**ARLINGTON COUNTY, VIRGINIA
OFFICE OF THE PURCHASING AGENT**

INVITATION TO BID NO. 23-CPHD-ITBPW-379

ADDENDUM NO. 3

Arlington County Invitation to Bid No. 23-CPHD-ITBPW-379 for renovations at 11th Street Park is amended as follows:

DRAWING NO.
R-2.0

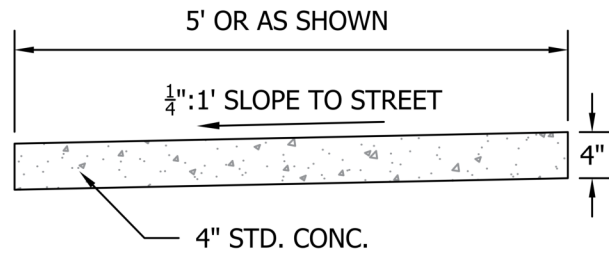
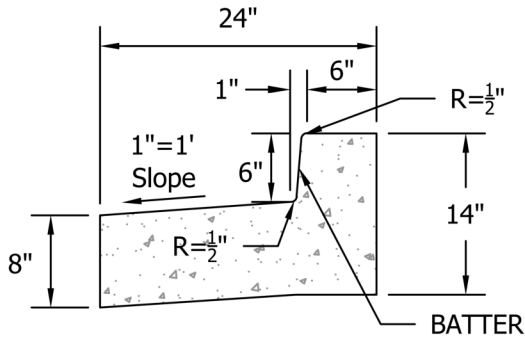
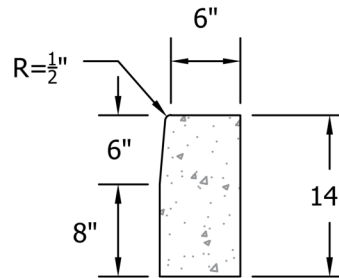
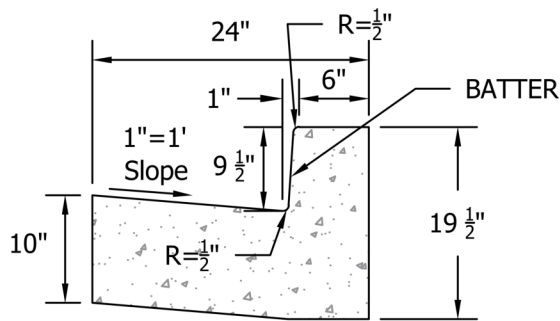
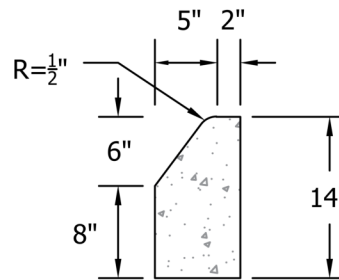
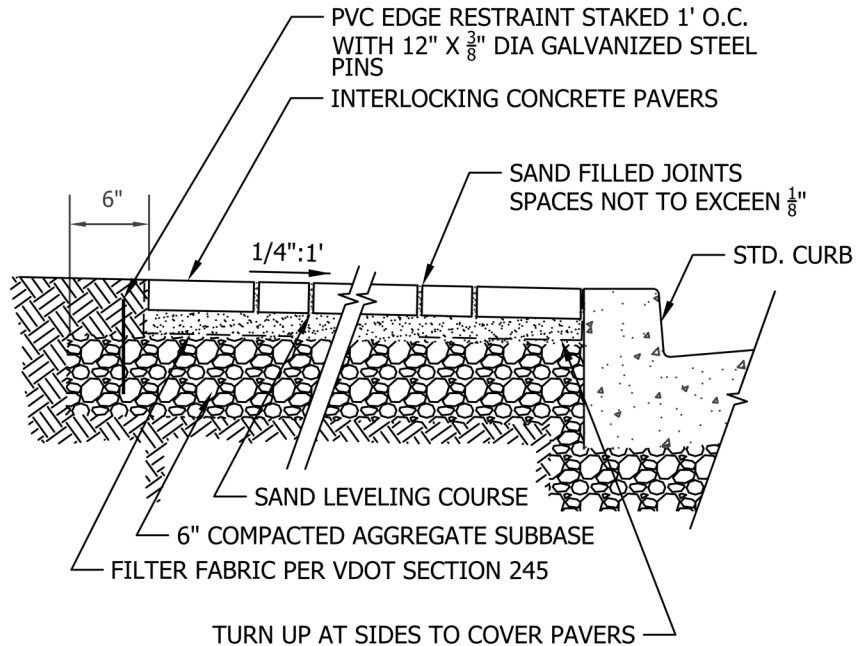
Q: Please provide a detail for brick paver and curb/gutter reinstallation.

A: Refer to Arlington County standard details R-2.0 and R-2.1 (attached).
